1.15 Department of Industry

Sydney Football Stadium Redevelopment

Groundwater levels

009

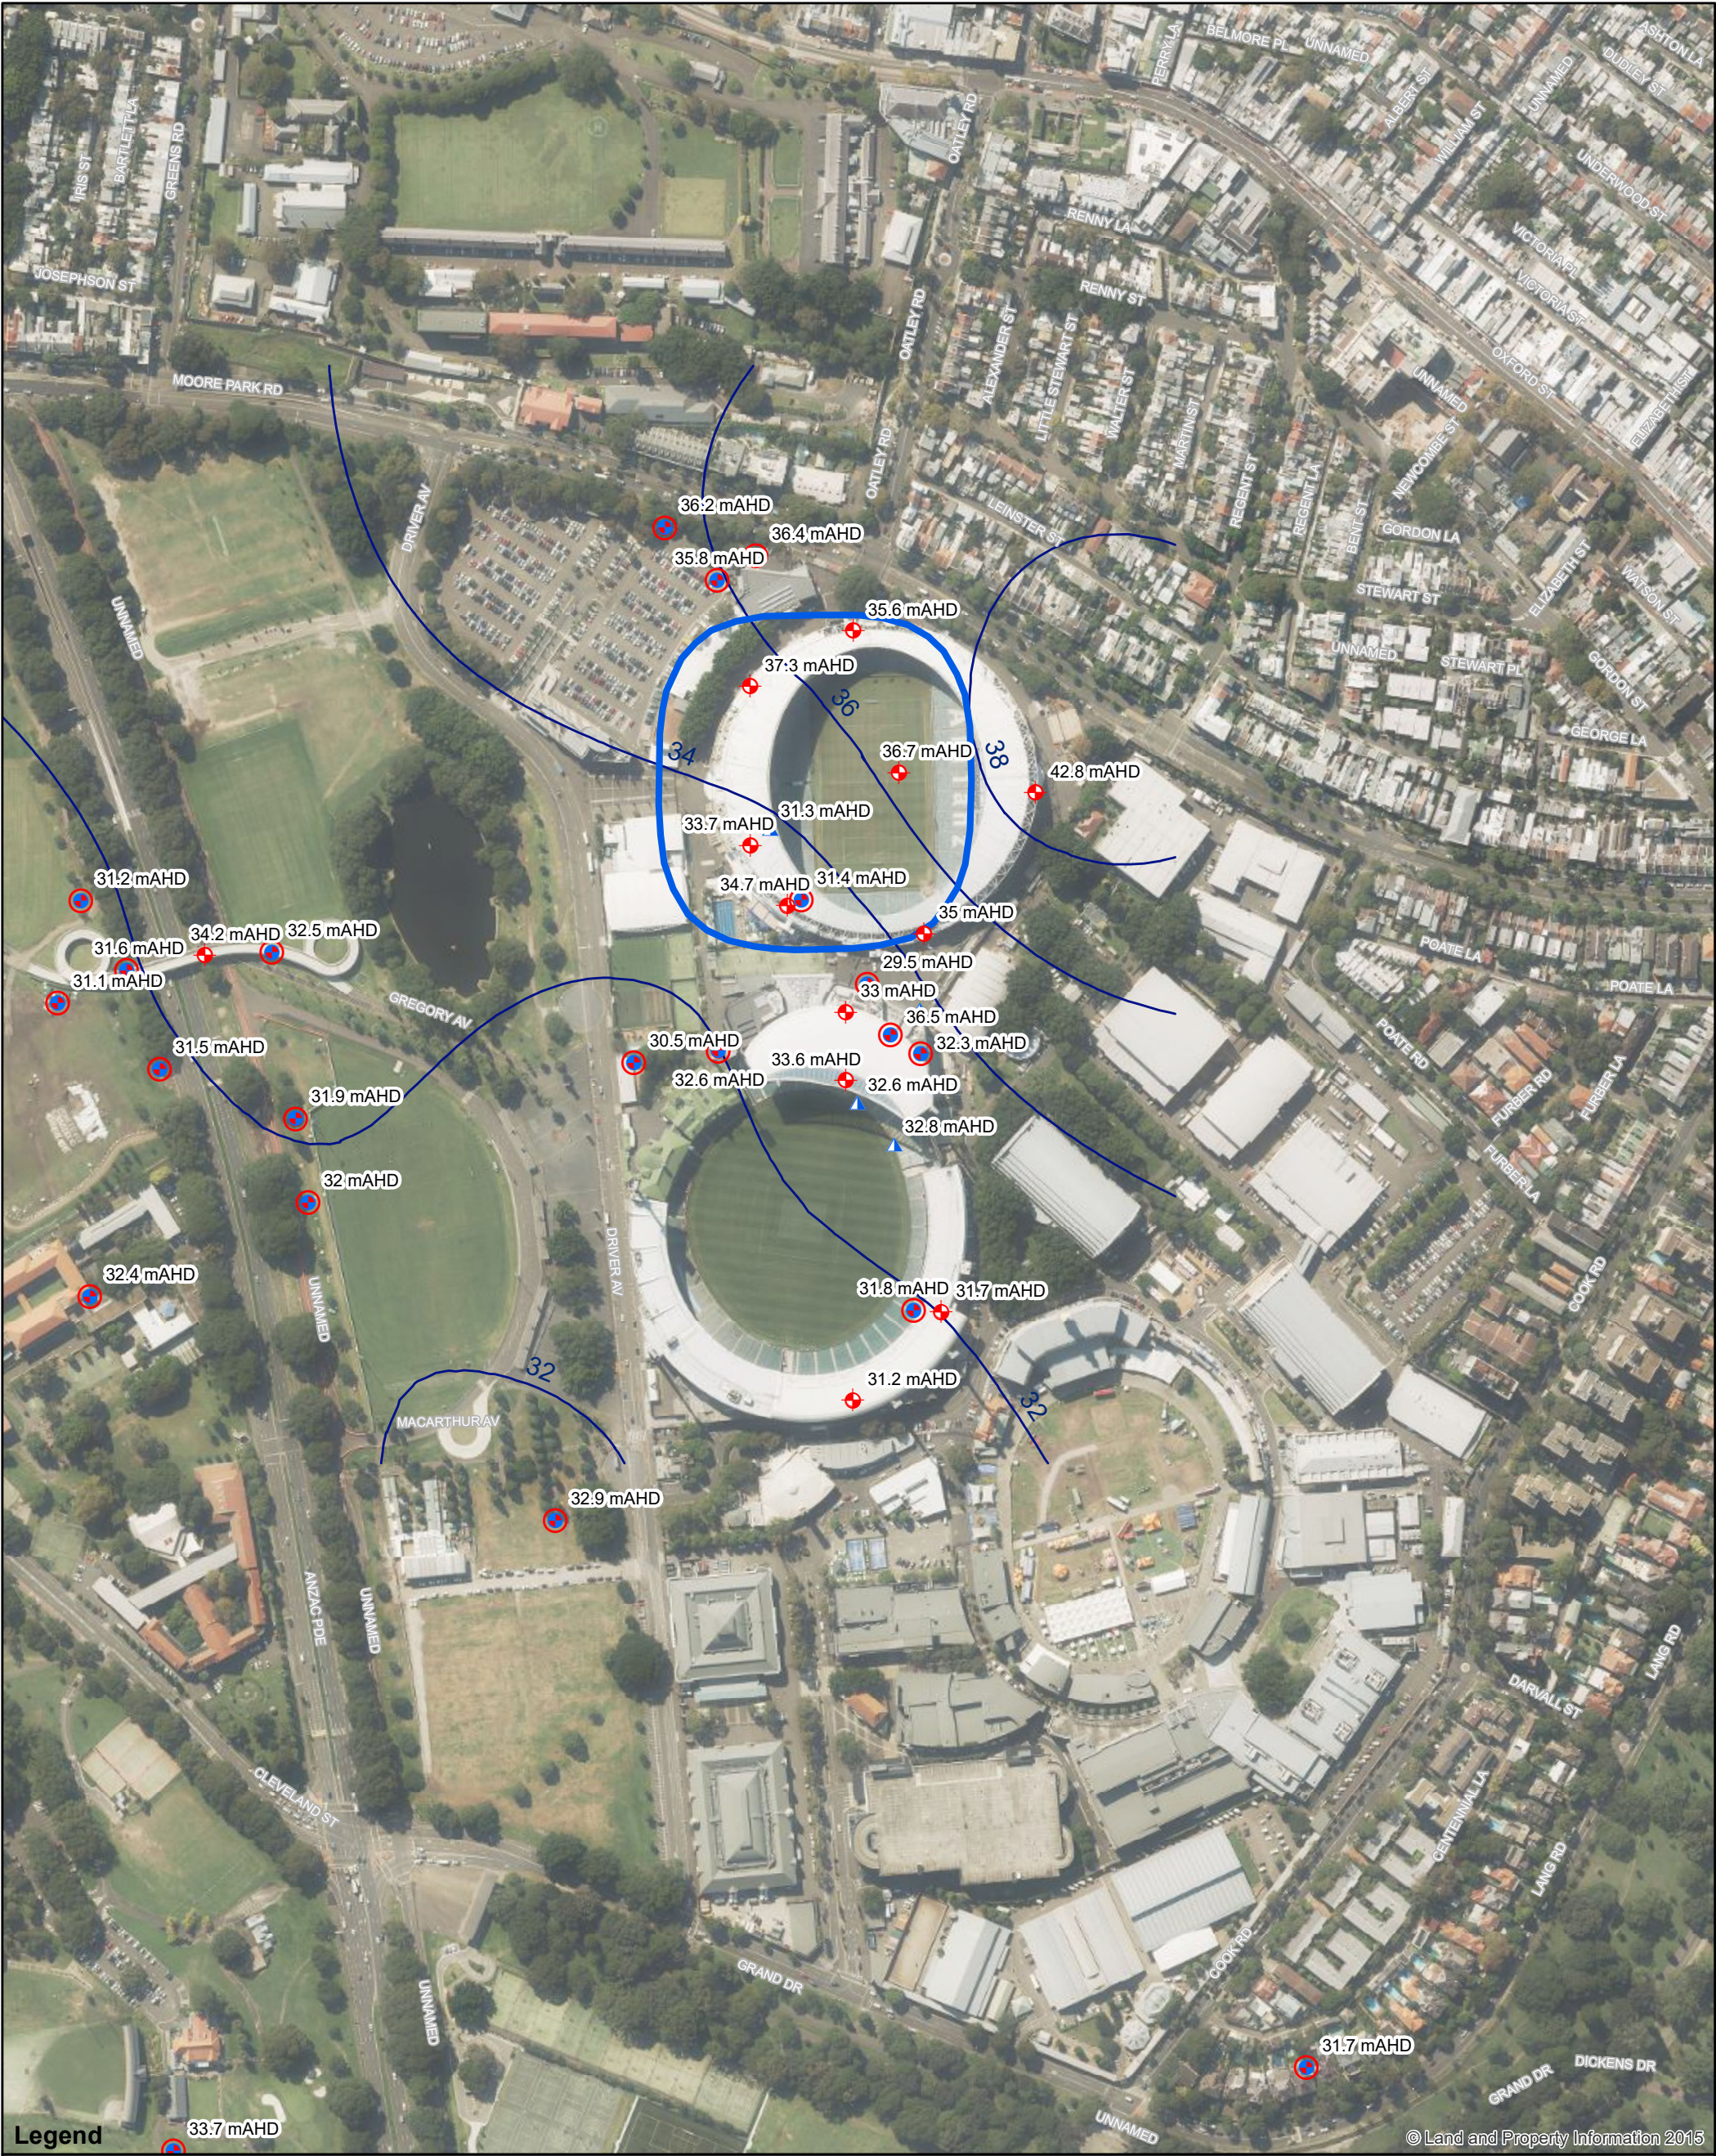
DI5	Ground contours should be shown on Figure 9 in the Groundwater Impact Assessment for reference.	Ground contours are shown on Figure 5 of the Groundwater Assessment Report (Appendix T to the EIS).
